Access Compliance Report

Public Rights-of-Way

(Curb Ramps)

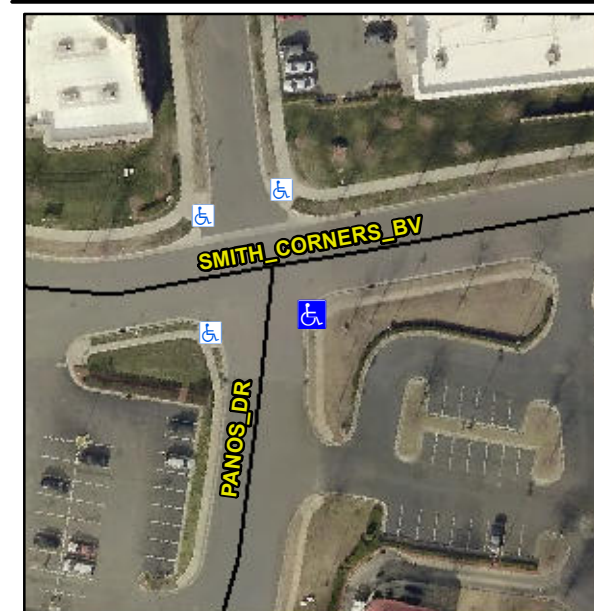
Intersection ID: 29957	Main Street: PANOS_DR	Cross Street: SMITH_CORNERS_BV	Location: SE
ADA ID: A73437FE542F	Ramp Type: PerpDiag	Initial Pass/Fail: Fail	Overall Compliance: No
Severity Score: 21.25			
Codes/Mitigation Info/Possible Solution		Field Measurements/Component Compliance

Not Found, R304.5.1, R304.2.2

Compliance	Description	Data	Compliance	Description	Data
N/A	Ramp Length (in)	47.5	No	Ramp Slope (%)	10.7
No	Ramp Width (in)	37.5	Yes	Ramp XSlope (%)	0.5
N/A	Flare Type LT	N/A	N/A	Flare Type RT	N/A
N/A	Flare Slope LT (%)	N/A	N/A	Flare Slope RT (%)	N/A
N/A	Flare Traversable LT?	N/A	N/A	Flare Traversable RT?	N/A
N/A	Landing Length (in)	N/A	N/A	DWS Provided?	N/A
N/A	Landing Width (in)	N/A	N/A	DWS Contrast?	N/A
N/A	Landing Slope (%)	N/A	N/A	DWS Length (in)	N/A
N/A	Landing X Slope (%)	N/A	N/A	DWS Full Width?	N/A
N/A	Landing Curb? (Y/N)	N/A	N/A	DWS Offset (in)	N/A
N/A	Shared Landing?	N/A			
N/A	Gutter Ponding?	N/A	N/A	Gutter Slope (%)	N/A
N/A	Gutter Lip Ht (in)	N/A	N/A	Gutter X Slope (%)	N/A
N/A	Painted X Walk1?	No	N/A	Painted X Walk2?	No
	X Walk 1 Direction	To N		X Walk 2 Direction	To W
N/A	X Walk 1 Width (in)	N/A	N/A	X Walk 2 Width (in)	N/A
	X Walk 1 Slope (%)	4.4		X Walk 2 Slope (%)	2.0
	X Walk 1 X Slope (%)	0.3		X Walk 2 X Slope (%)	0.6

Remove & Replace Curb Ramp With Two New Directional Ramps or Equivalent.
